Harwich Planning Board Meeting Agenda

PB2020-28 Cape Cod Oil

Staff Report- May 11, 2021 Public Hearing (continued from April 13, 2021)

Re: Response to Comments Letter Cape Cod Oil – Site Plan Review Application 6 Station Avenue, Harwich, MA 02645 IDE Project Number: 01-2020-015

JOB NUMBER: 01-2020-015

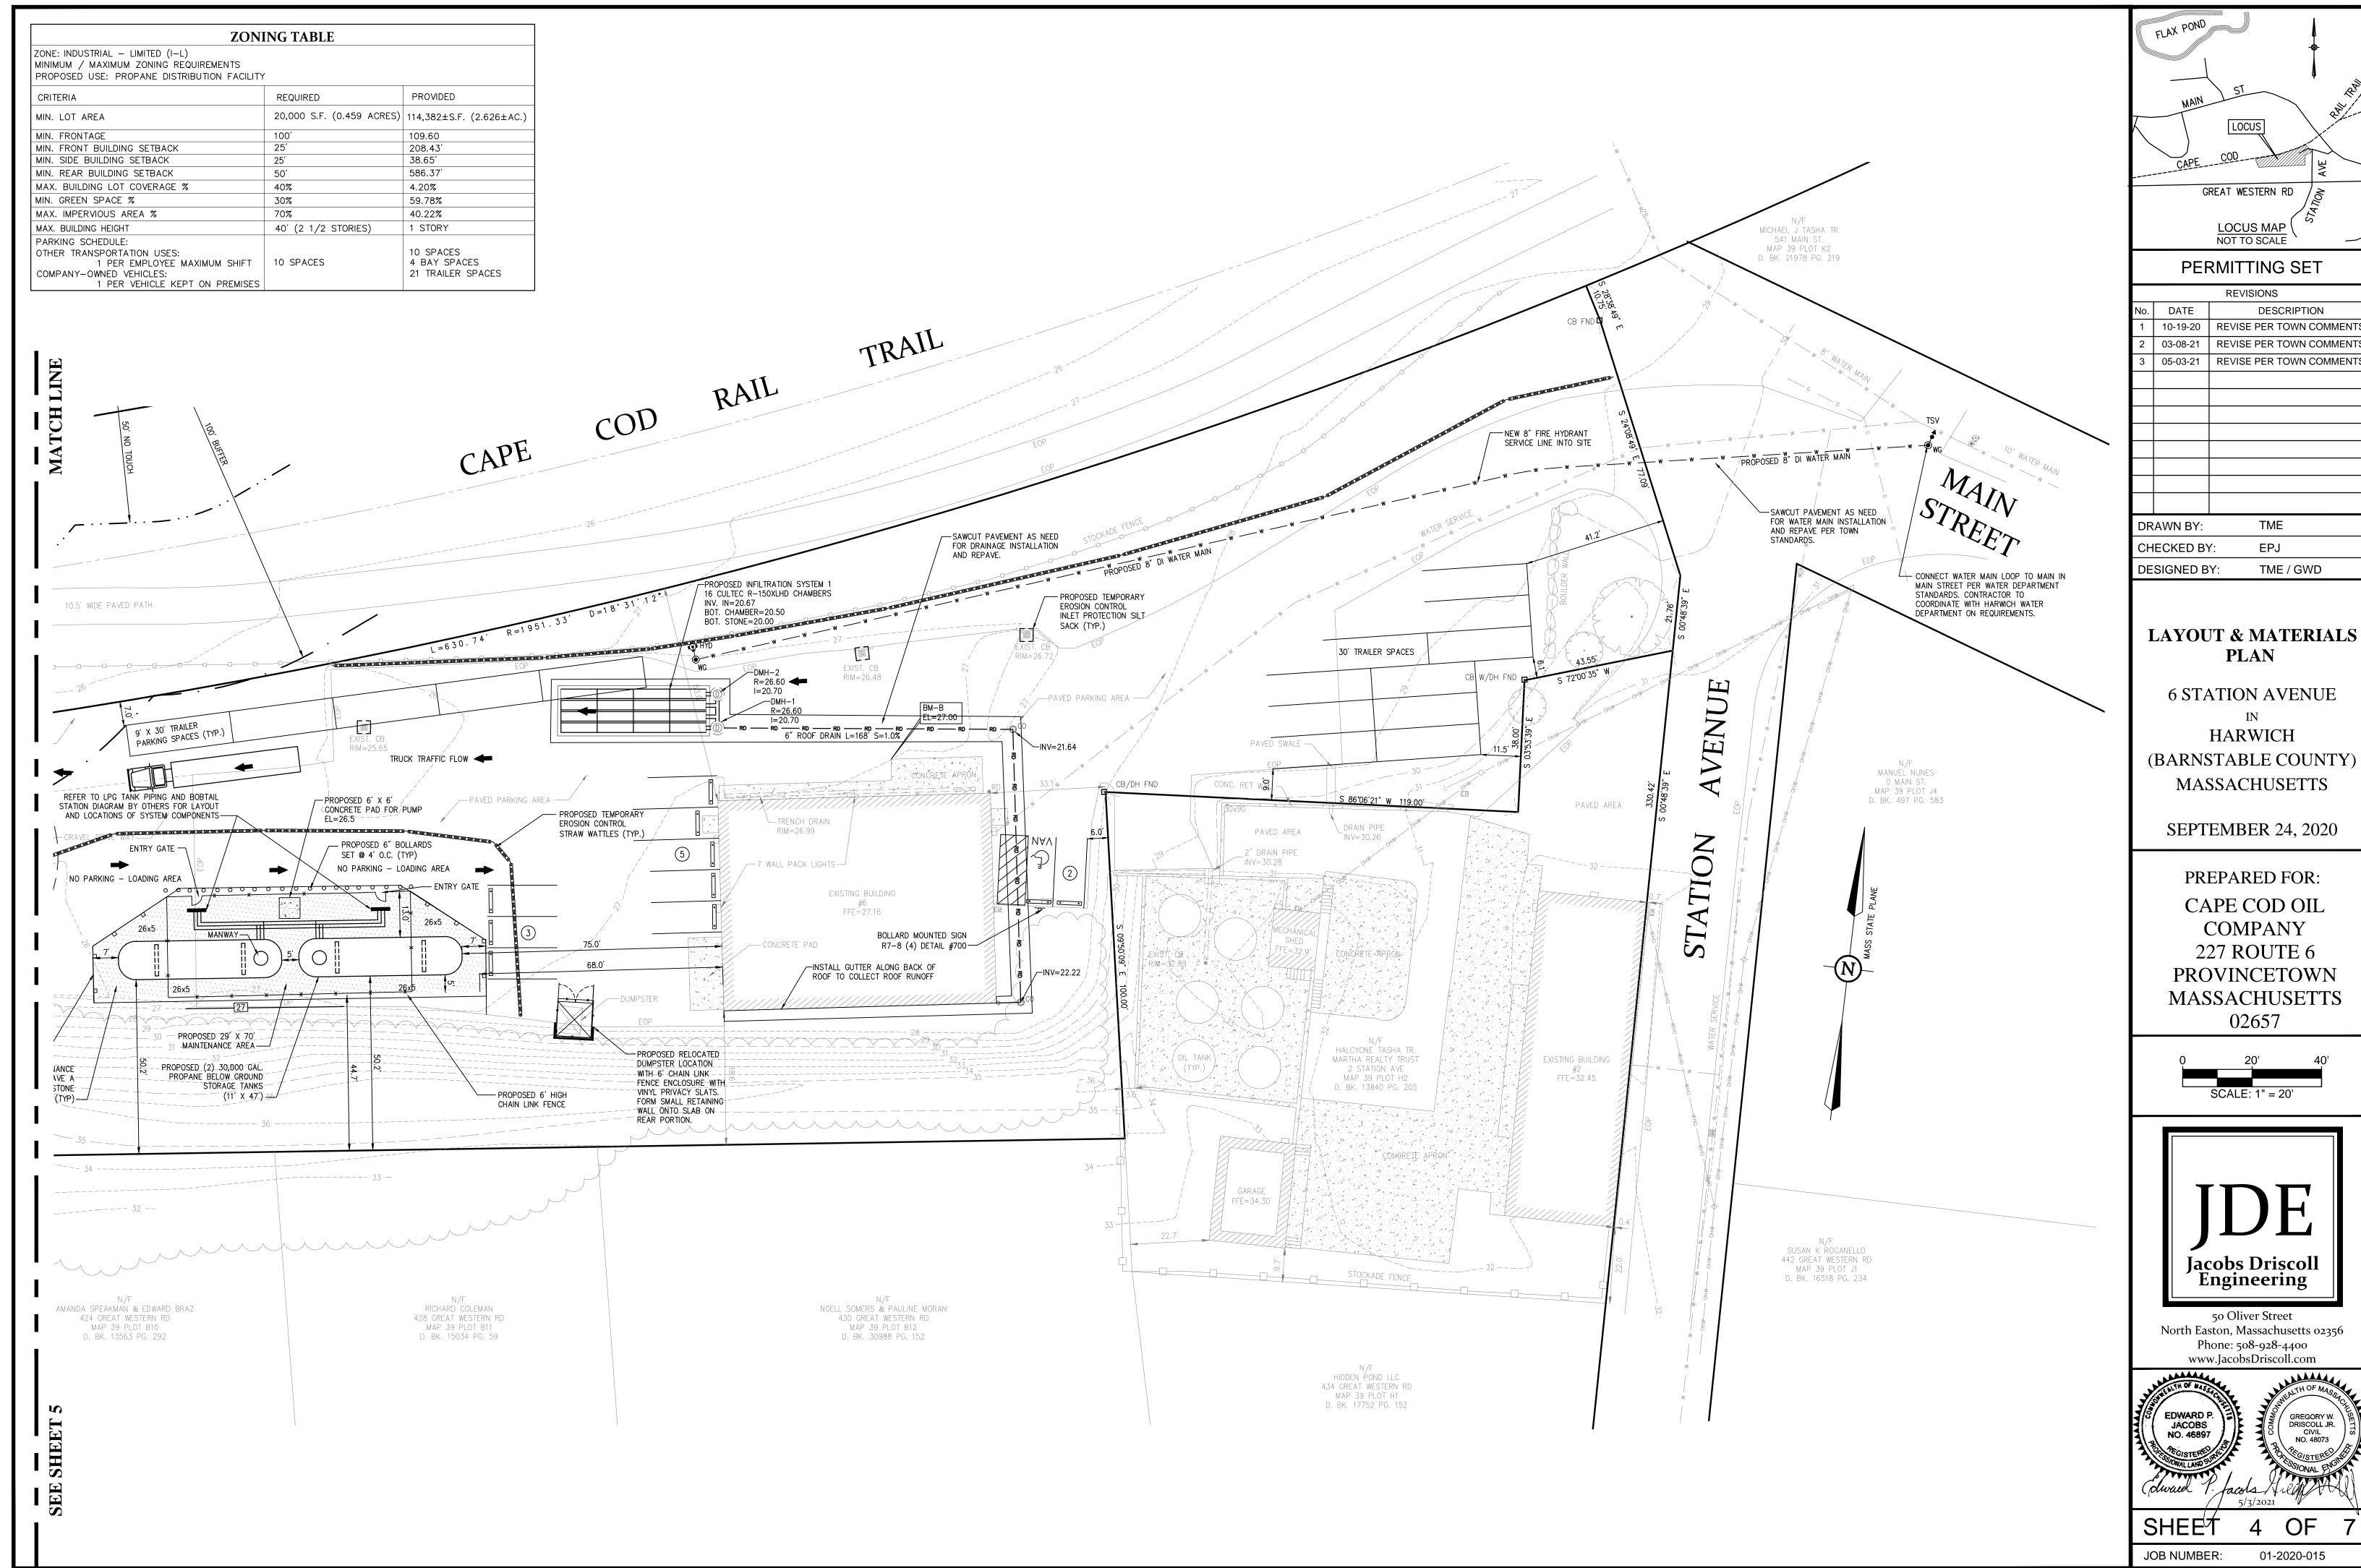
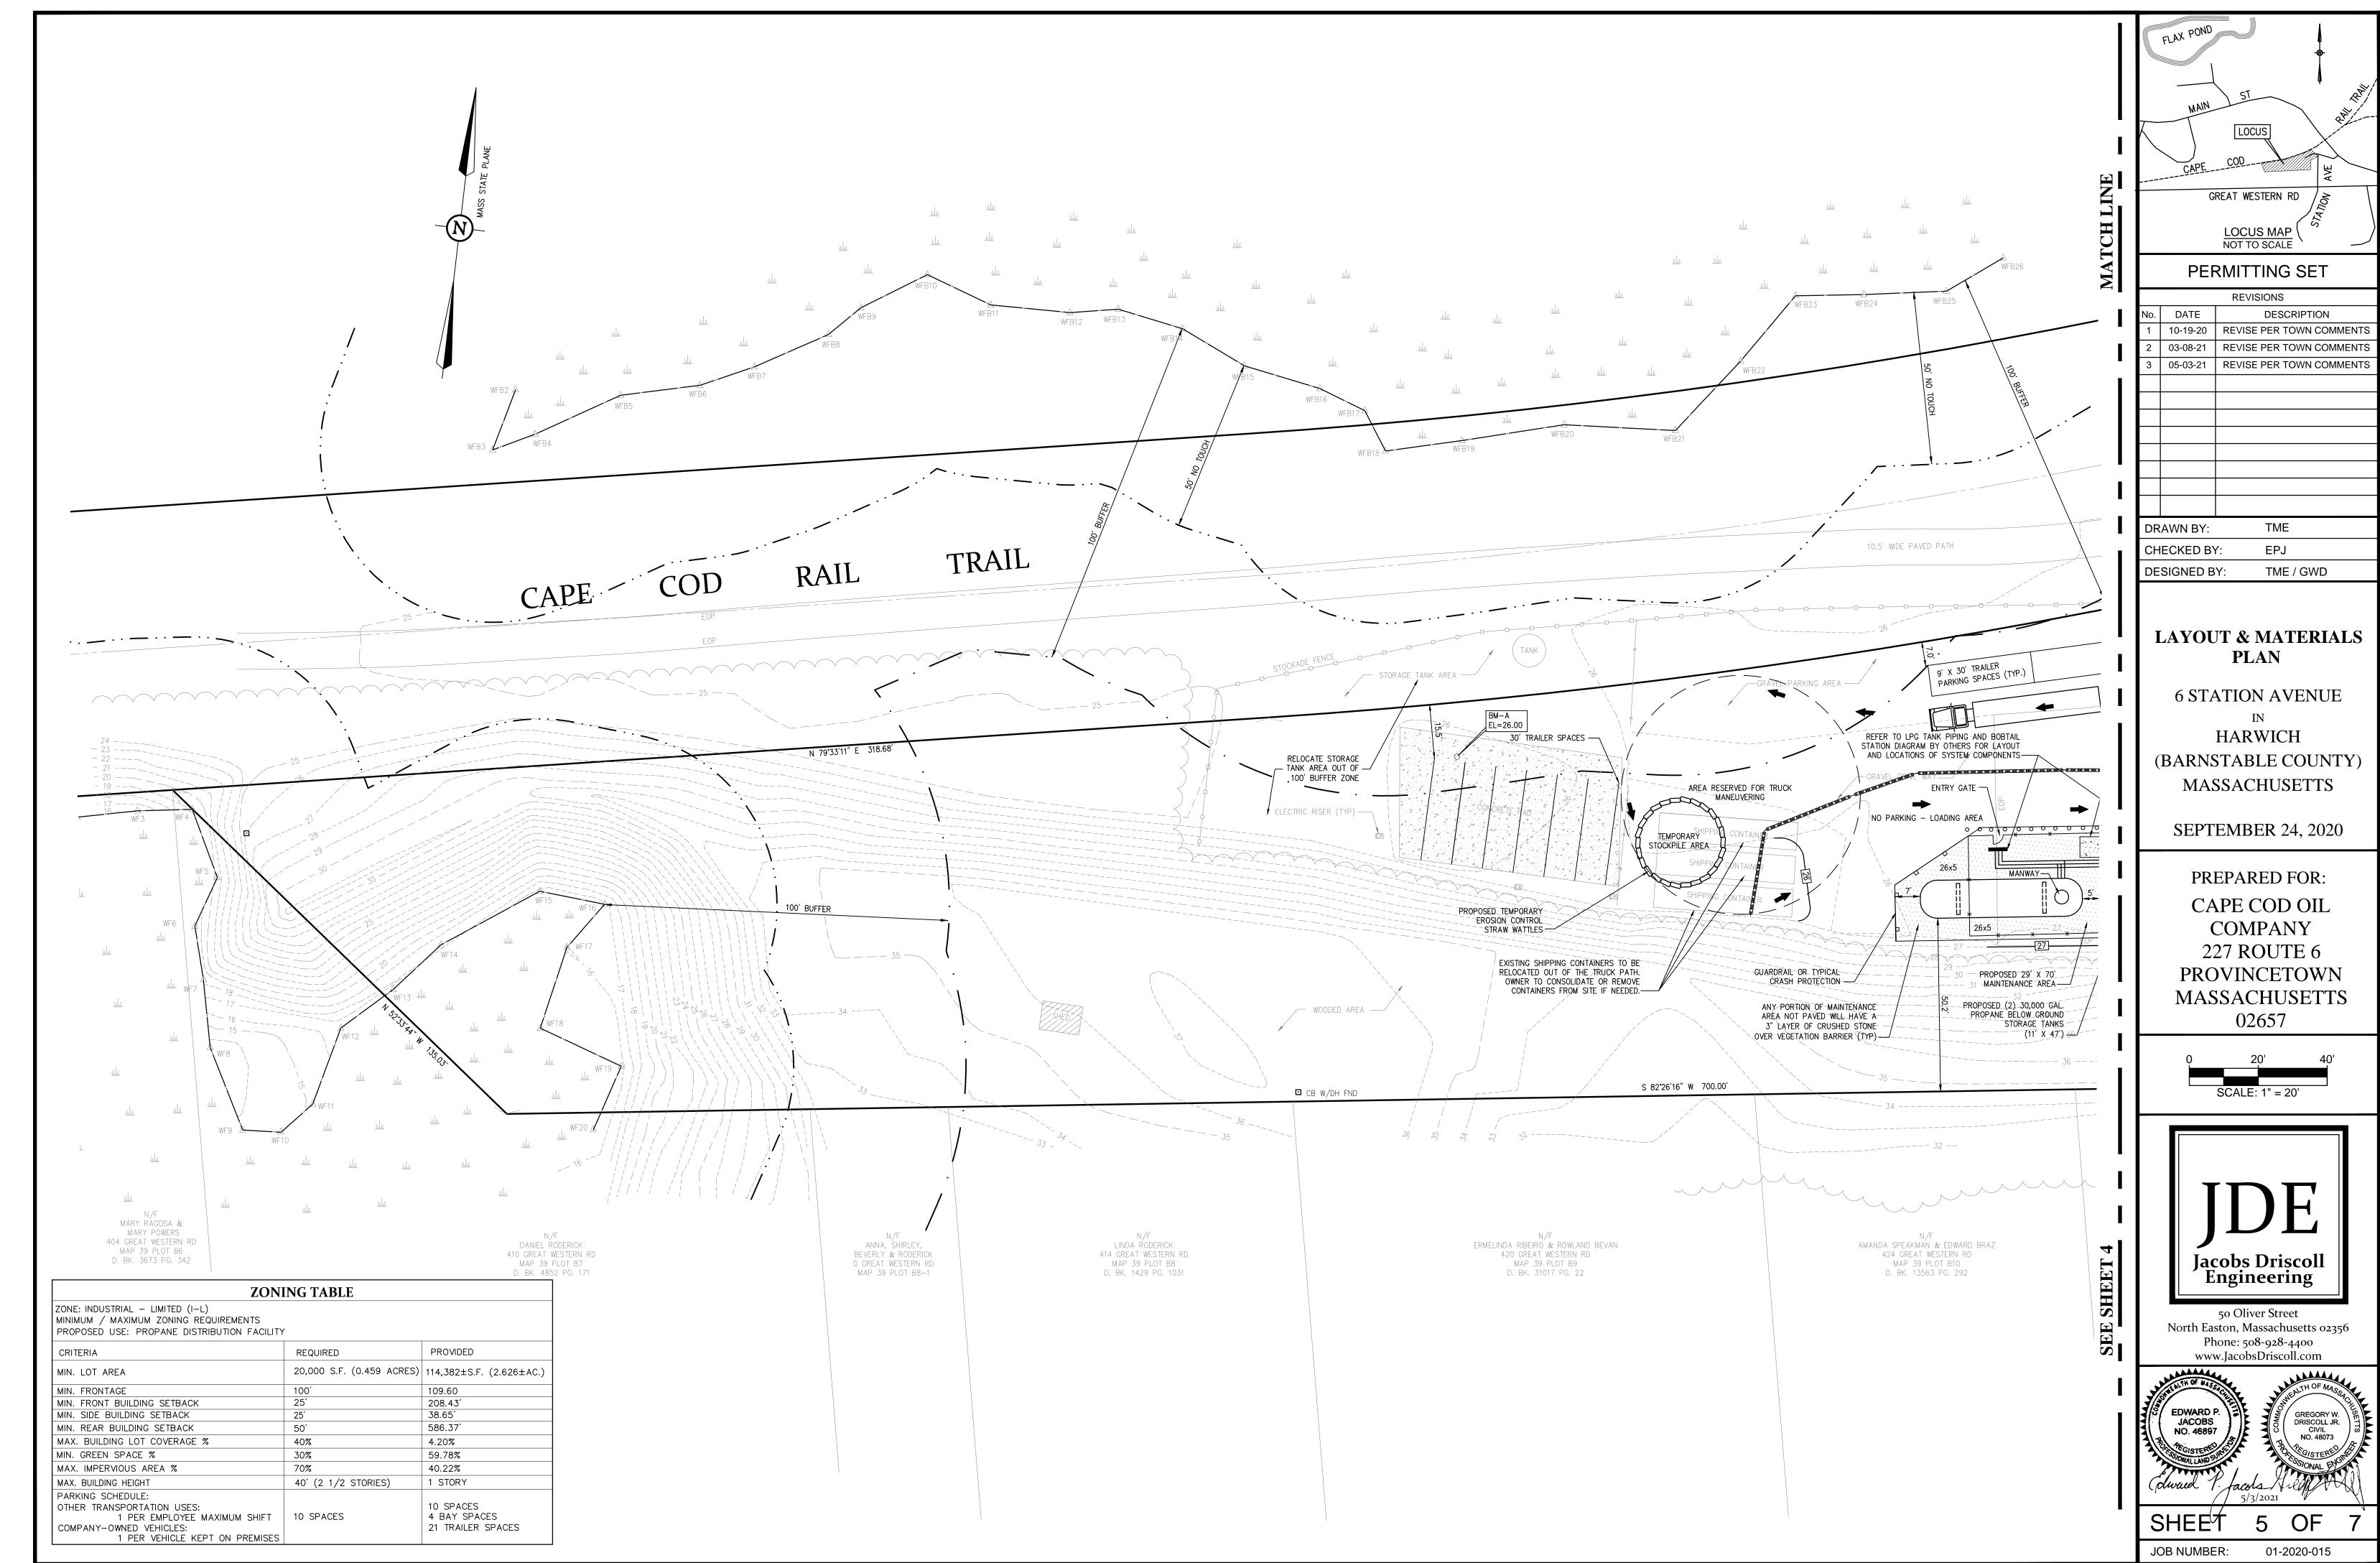
12. Comment – At this time I saw storage space for 10 trailers on site. It is currently undetermined where the other twelve may be stored or where they may be located in the future.

2. Comment – The area marked storage tank area and the stockade fencing along a portion of the north boundary line is encroaching on the Cape Cod Rail Trail. An easement must be provided for continued permission to for this use.

3. Comment – There are three shipping containers and a shed shown on the existing conditions plan. Uses for these items should be determined, particularly the containers if they are to be located. If relocated, the plan and approval shall be incorporated into the findings and decision. This may require re-examining the parking schedule.

JDE Response – As shown on Sheets 4 & 5 of the plan set, there are 22 proposed trailer spaces on this site. 6 trailer spaces are proposed along the edge of pavement to the north, 6 trailer spaces are proposed on the concrete pad on the west end of the property, and 10 trailer spaces are proposed along the boulder wall at the east end of the property.

JDE Response – The storage tank area will be relocated out of the 100' buffer zone as shown on the plan.

JDE Response – The existing shed shown on the plan will remain as the owner is not utilizing it at this time. The three existing shipping containers will be consolidated and relocated or removed as needed. Proposed locations for the containers are not known at this time. The owner will either remove/relocate to an appropriate location as needed.
